SAFETY NOTICE

SN681A

MODELS AFFECTED: TM Aerial Devices

SUBJECT: Leveling Sensor Installation

Figure 1 – Level Sensor Location on End Mount Machine

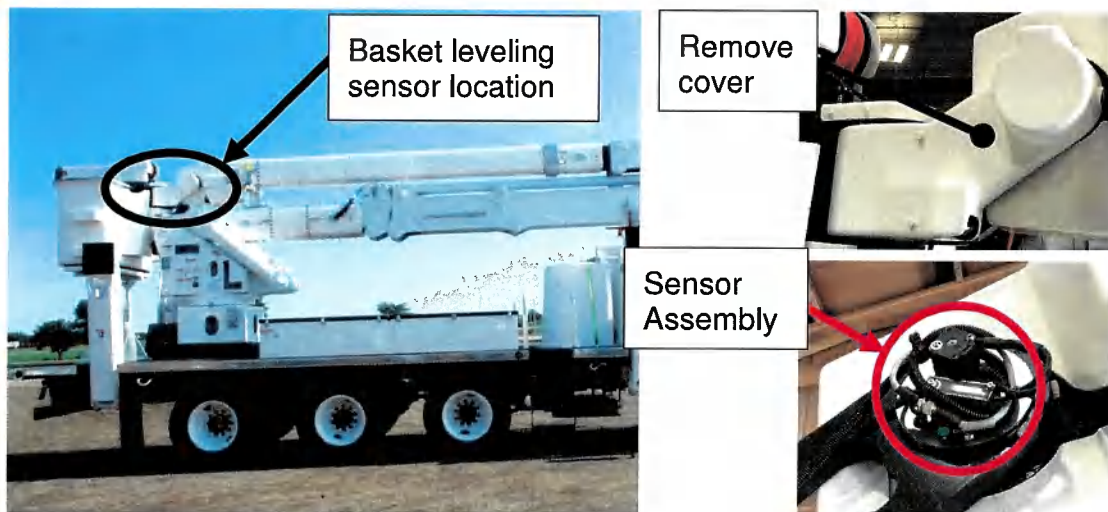
1. Inform all users, operators, and supervisors that the basket level sensors must be inspected within 10 days on TM aerial devices and follow the continued use section of this bulletin until the unit is corrected. This bulletin applies to TM Aerial devices with the hydraulic generator at the boom tip and applies to machines with an end mount platform or dual side mount platforms.
2. Inspect the unit to determine if your unit has the incorrectly installed level sensors.

Figure 3A
This bulletin applies if the light colored potting visible on the top sensor, or sensor labeled A on the bottom

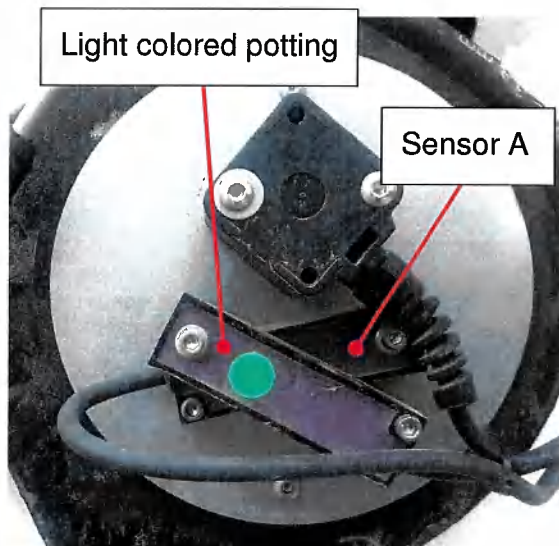
3. If your unit has the light colored potting visible on the top sensor, or the sensor labeled A on the bottom; this bulletin applies. Correct following the instructions in Field Service Kit Z1562. Take a picture before correcting the issue and another picture after correcting the issue. Send both pictures with the completion form including the serial number and date of correction to utilities.warranty@terex.com.
4. If your unit has the light colored potting visible only on the bottom sensor with the wires coming out of the sensors above the mounting screw and with sensor labeled A on top this bulletin does not apply and use can continue without restriction.

Figure 4B

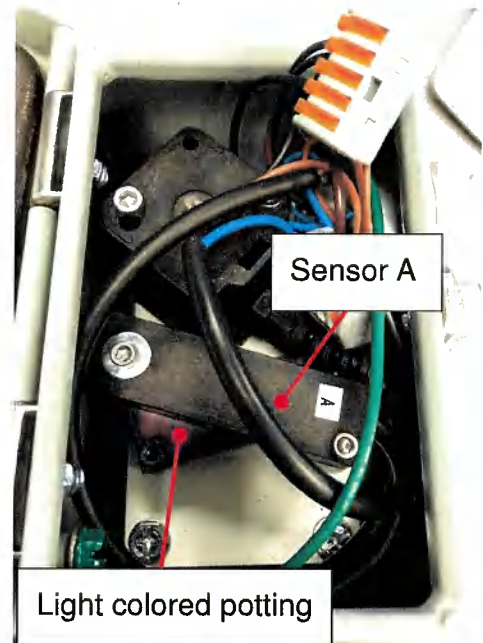
This bulletin does **NOT** apply if the light colored potting only visible on bottom sensor and sensor labeled A on top
